Agenda
Village of Arlington Heights
Design Commission
Buechner Room, 1st Floor

MINUTES OF
THE VILLAGE OF ARLINGTON HEIGHTS
DESIGN COMMISSION MEETING
HELD AT THE ARLINGTON HEIGHTS MUNICIPAL BUILDING
33 S. ARLINGTON HEIGHTS RD.
MARCH 14, 2017

Department: Planning & Community Development

West Elevation

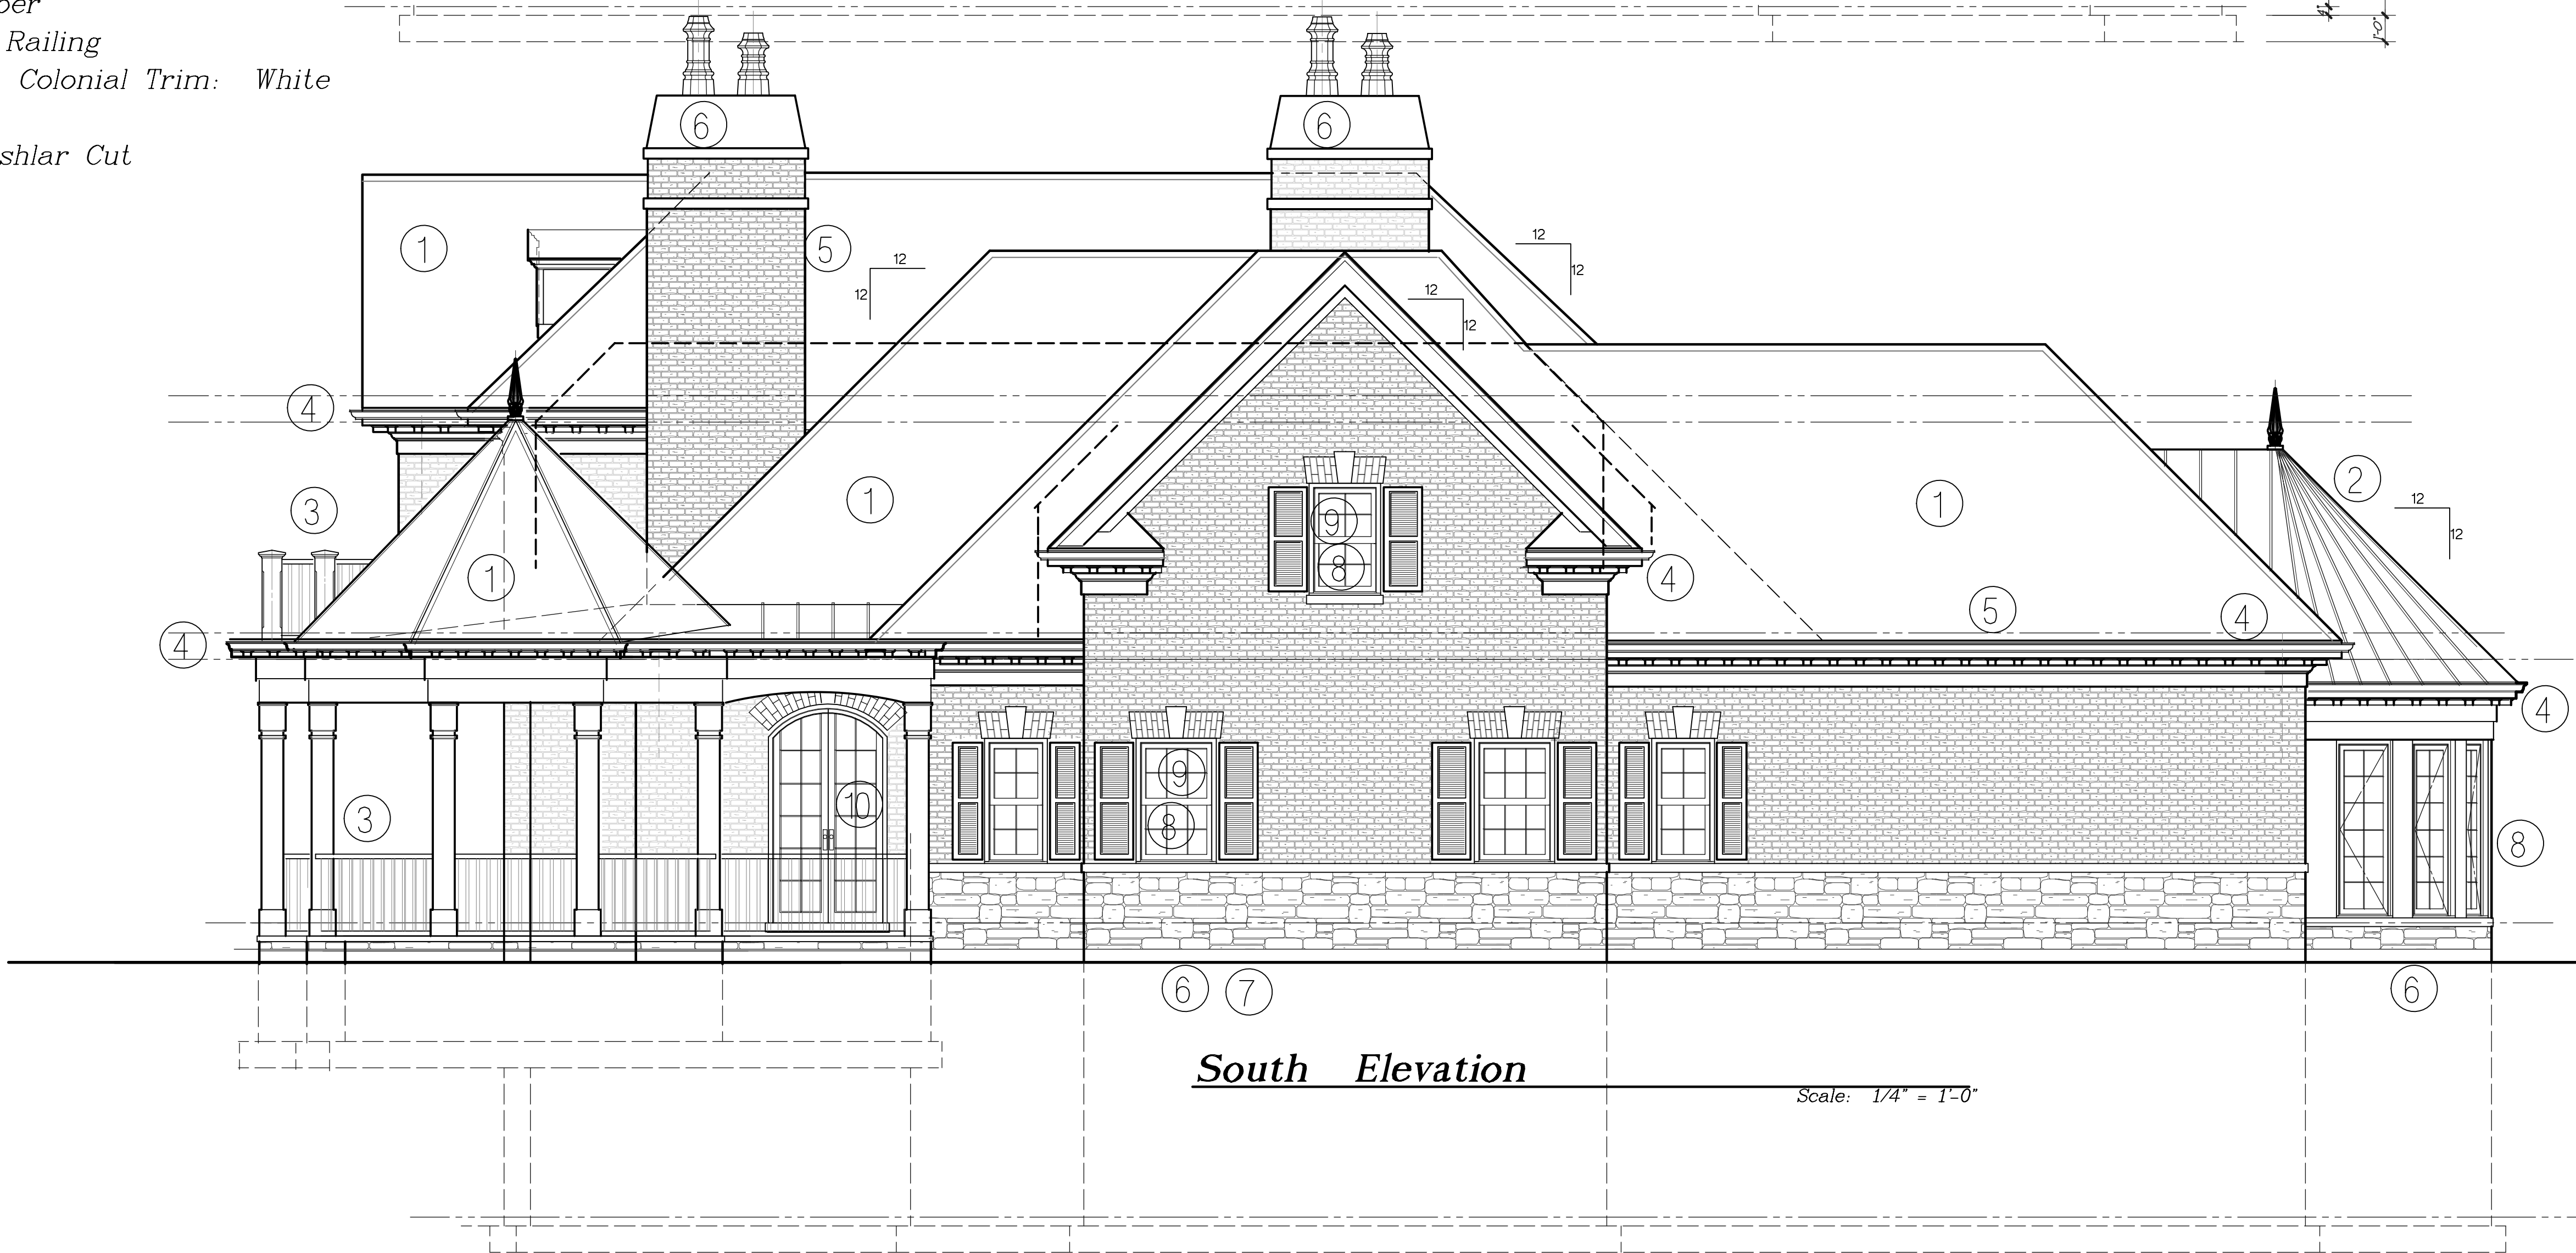
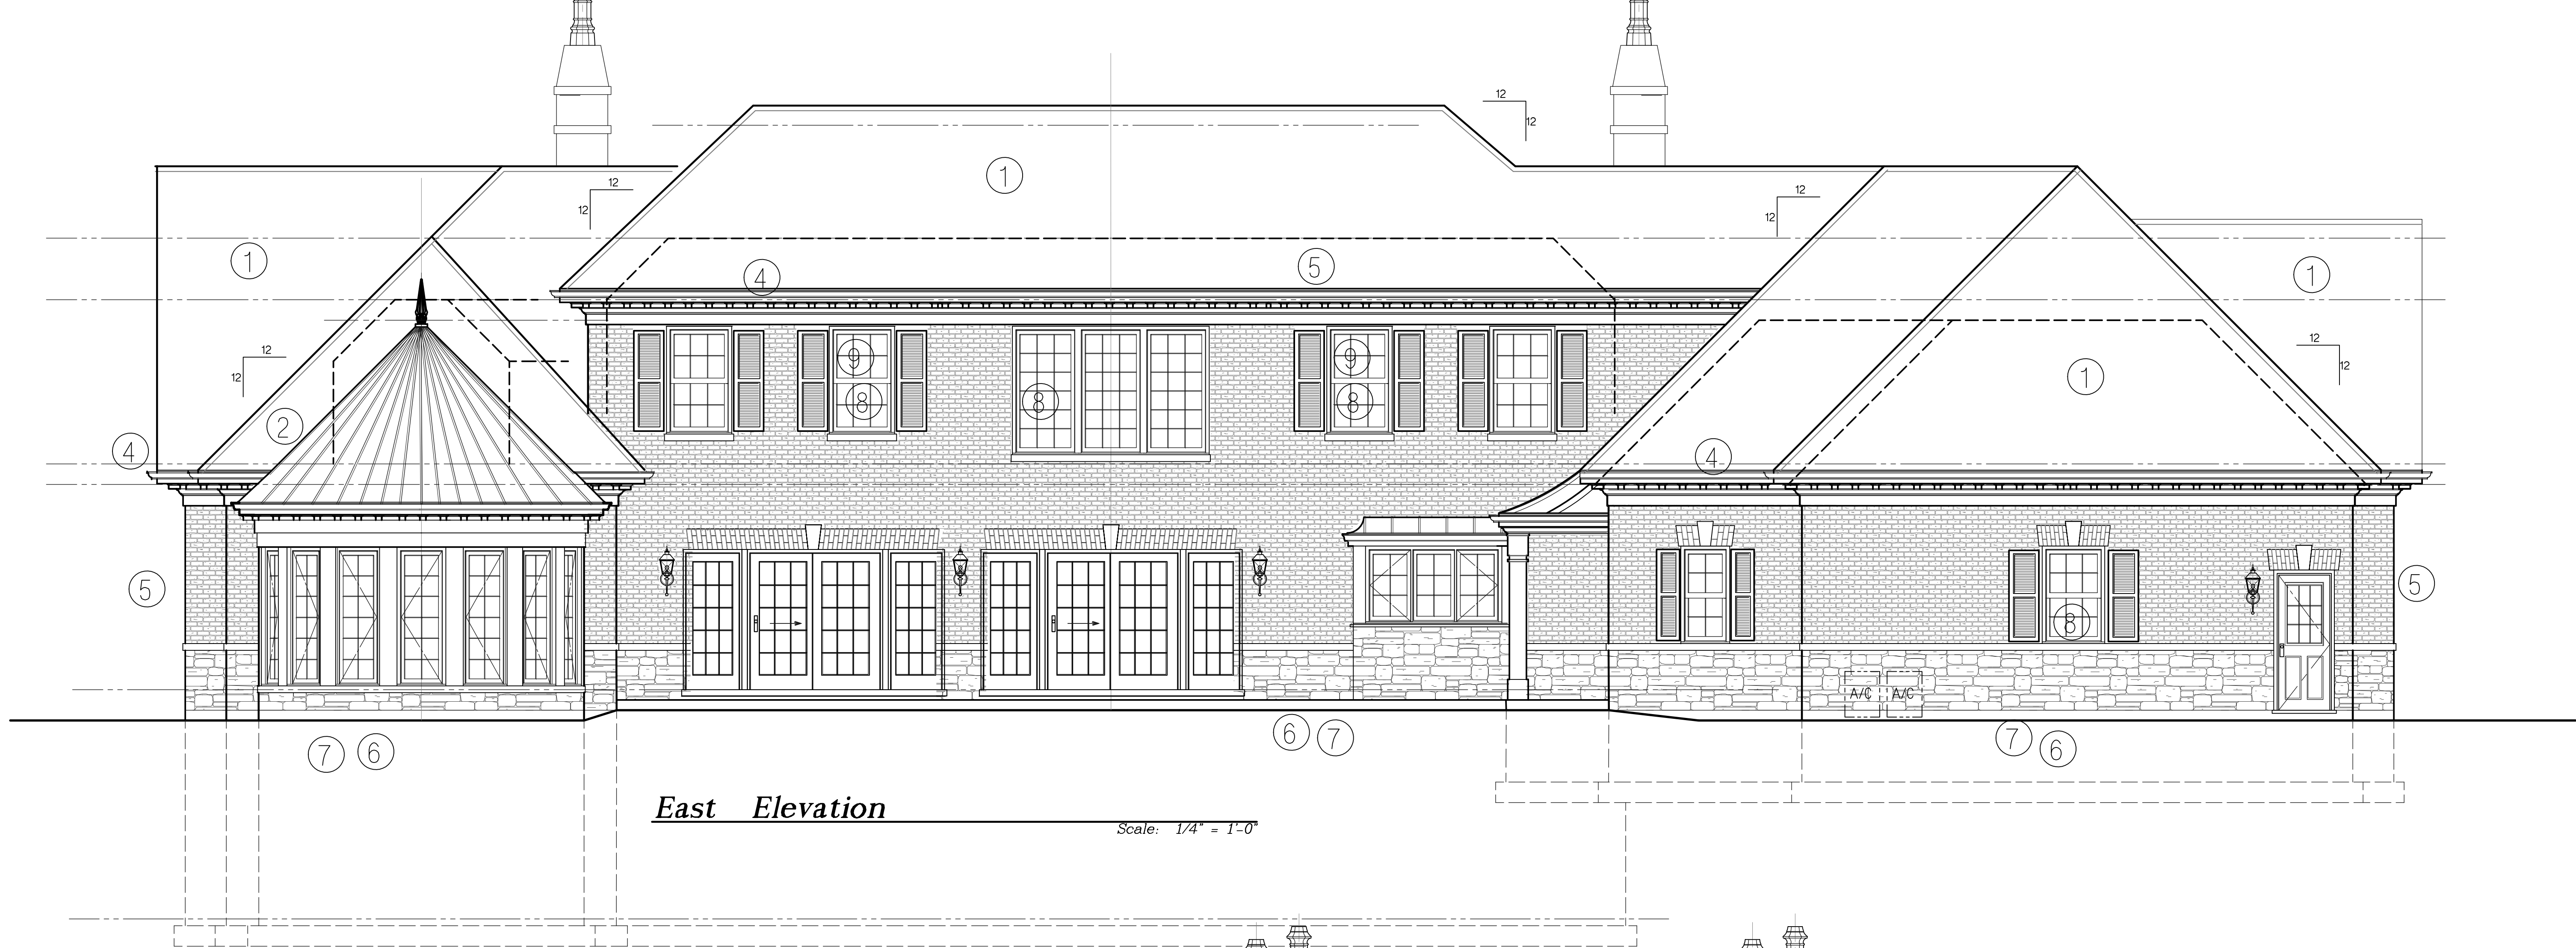
It is recommended that the Design Commission approve the proposed new single-family residence to be located at 845 S. Bristol Lane. This recommendation is subject to compliance with the architectural plans dated and received 2/23/17, and the following:

1. Provide landscaping along the edge of the driveway to soften the view of the garage from the adjacent property.
2. This review deals with architectural design only and should not be construed to be an approval of, or to have any other impact on, any other zoning and/or land use issues or decisions that stem from zoning, building, signage or any other reviews. In addition to the normal technical review, permit drawings will be reviewed for consistency with the Design Commission and any other Commission or Board approval conditions. It is the architect/homeowner/builder's responsibility to comply with the Design Commission approval and ensure that building permit plans comply with all zoning code, building permit and signage requirements.
3. Compliance with all applicable Federal, State, and Village codes, regulations and policies.
